**PLANNED UNIT DEVELOPMENT,
PLANNING APPROVAL &
SUBDIVISION STAFF REPORT****Date: September 5, 2013**

<u>NAME</u>	Blue Creek Coal Terminal Subdivision
<u>SUBDIVISION NAME</u>	Blue Creek Coal Terminal Subdivision
<u>LOCATION</u>	80 Virginia Street (Area bounded by CSX Railroad, New Jersey Street, Old Water Street, and Mobile River, extending to the North side of Virginia Street, 465'± East of Conception Street))
<u>CITY COUNCIL DISTRICT</u>	District 2
<u>PRESENT ZONING</u>	I-2, Heavy-Industry District
<u>AREA OF PROPERTY</u>	1 lot / 36.9 acres ±
<u>CONTEMPLATED USE</u>	Planning Approval to allow a coal handing terminal in an I-2, Heavy-Industry District, Planned Unit Development approval to allow multiple buildings on a single building site, and Subdivision approval to create one legal lot.
<u>TIME SCHEDULE FOR DEVELOPMENT</u>	After appropriate approvals are obtained.

SITE PLAN

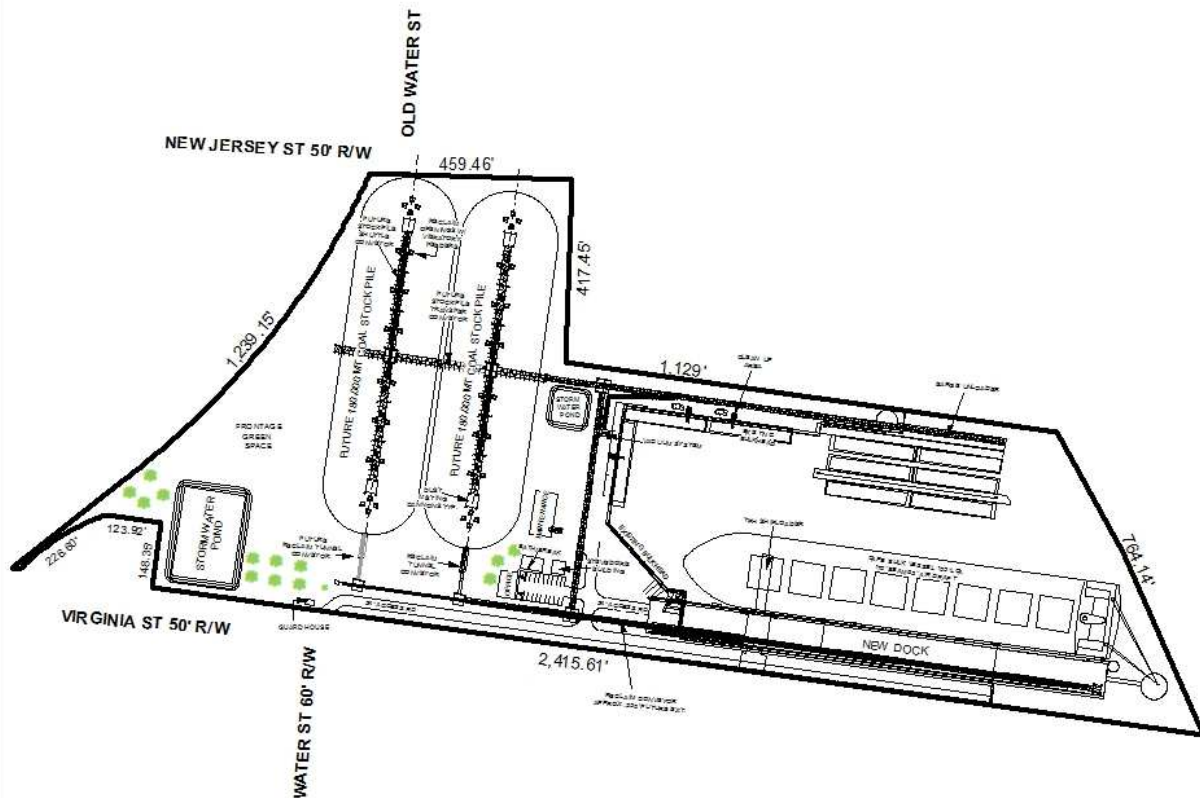
The site plan submitted with the application depicts one proposed curb-cut to Virginia Street. As PUD and Planning Approval review are site plan specific, the site should be limited to the single proposed curb-cut, with the size, design and location to be approved by Traffic Engineering, and to comply with AASHTO standards. It should be noted, however, that the presence of a guard building at the entrance to the site implies to staff that the entrance may be gated. If an entry gate is proposed, it should be depicted on the site plan and it should be set at least 60-feet from the right-of-way of Virginia Street so that emergency vehicles will have sufficient room to turn around if necessary.

The site plan depicts trees and landscape areas on the site. As the site is in an I-2 zone, only frontage trees are required. Calculations by staff indicate that 14 frontage trees are required, to be planted within the 25-foot setback along the Virginia Street frontage. Only 13 trees are depicted, and none appear to be within the setback area. Measurements of the site area by staff indicate that the non-navigable water portion of the site is no more than 22 acres of the total 36.9 acres. As such, the landscape area calculations on the site plan should be revised to only consider the dry land area, not any portion of the site over water (such as a dock), or the water area associated with the Mobile River: essentially any area behind the bulkhead should provide the basis for the landscape area calculations. The site plan and calculations should be revised to reflect the reduced landscape area requirements.

The site plan does not indicate which portions of the on-site access road will be paved, versus surfaced with aggregate or other materials. The site plan should be revised to depict paved versus aggregate surfacing. Additionally, the parking area should include concrete wheel stops if no curb-and-gutter will be provided.

Finally, the 25-foot minimum building setback line is depicted on the preliminary plat but is not depicted on the site plans. The site plans should be revised to also depict the 25-foot minimum building setback line.

A revised site plan indicates that the coal will be unloaded from barges utilizing a gantry continuous unloader with dust misting sprinkler with surfactant injection. The coal then travels by a conveyor with a continuous dust cover to the stockpiles, where it is deposited using telescoping dustless chutes. The stockpile dust is controlled using misting cannons. Coal is then transferred from the stockpiles to conveyors with continuous dust covers, with dust suppression fog cannons in use as the coal is moved from the stockpile to the conveyors, to the receiving bulk vessel. Coal is transferred from the conveyor system to the vessel by a dock conveyor with a dustless telescoping loading chute.

Staff has concern regarding the source of water that will be used for dust suppression, and the nature of the surfactants that will be used in the water, and their potential impact on the adjacent Mobile River if they drift or drain into the river.

- 1) Subject to approvals by state and national environmental agencies of the proposed use, as required;
- 2) Subject to implementation, at minimum, of the dust control measures indicated on the revised site plan and associated dust control product brochures;

- 3) Revision, if necessary, to label the correct size of the lot in square feet and acres, to match that on the final plat;
- 4) Revision of the site plan to depict any proposed entrance gate at least 60 feet from the edge of the Virginia Street right-of-way;

- 5) Revision of the site plan to depict the 25-foot minimum building setback line from Virginia Street;
- 6) Revision of the site plan to depict 14 frontage trees located within the 25-foot minimum building setback;

- 7) Revision of the site plan and landscape area calculations to only provide frontage and total landscape area based upon only that portion of the site that is actual land (that is, behind the bulkhead);

- 12) Development of the site must comply with all local, state and federal regulations regarding development within a flood zone;
- 13) Revision of the site plan to indicate which portions of the on-site access road and parking area will be paved in asphalt, concrete or similar, versus aggregate;

- 14) Depiction of concrete wheel stops in the parking area if no curb-and-gutter will be provided;
- 15) Submission of a revised site plan to the Planning Section prior to the signing of the final plat; and

DETAIL SITE PLAN

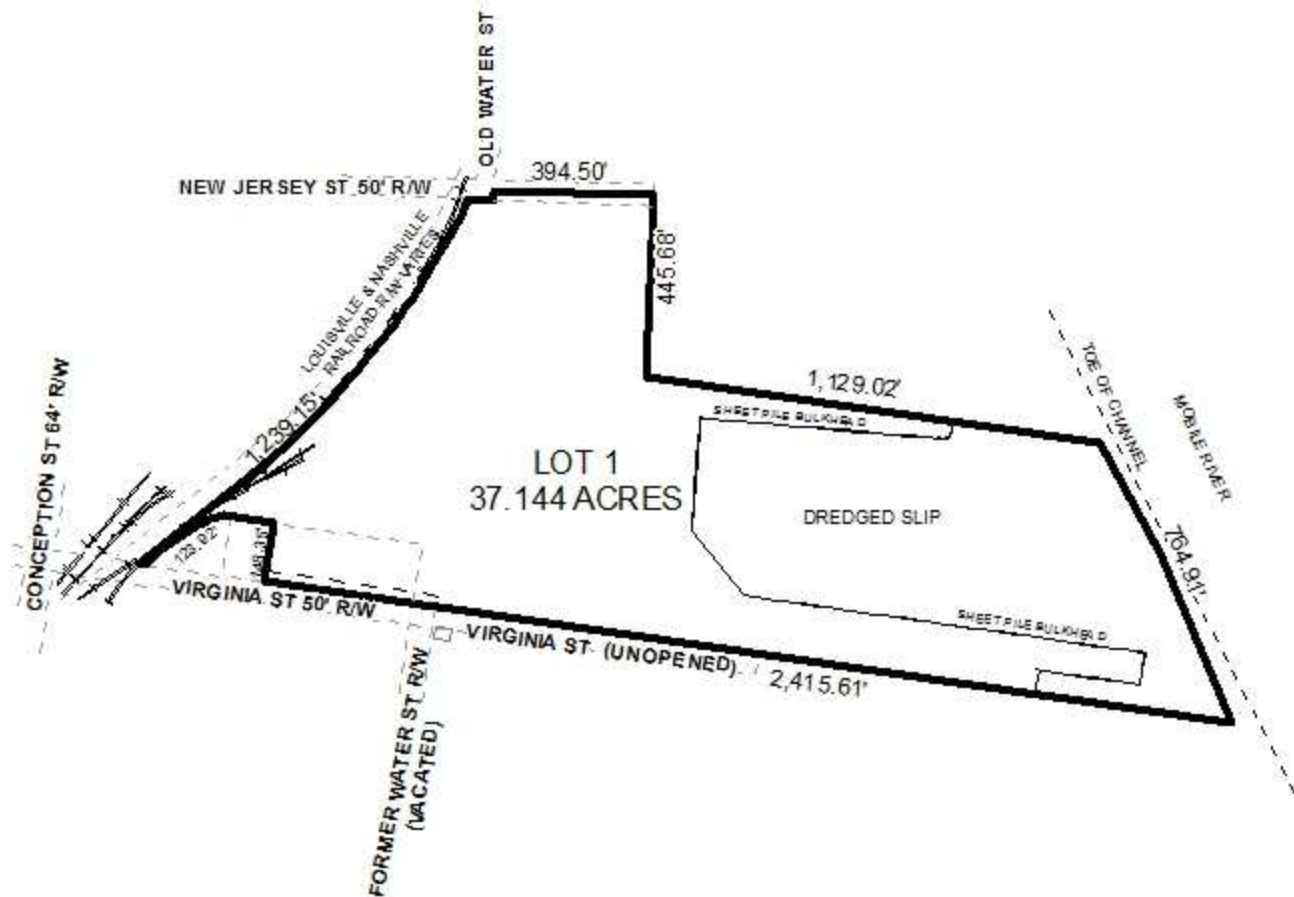
The proposed buildings on the site include a 2,400 square foot office, a 1,500 square foot bathroom and break room building, a 900 square foot stevedore building, and a 5,000 square foot maintenance facility. Twenty (20) parking spaces are proposed, which will comply with the requirements of the Zoning Ordinance. A guard building is also proposed as the entrance to the site.
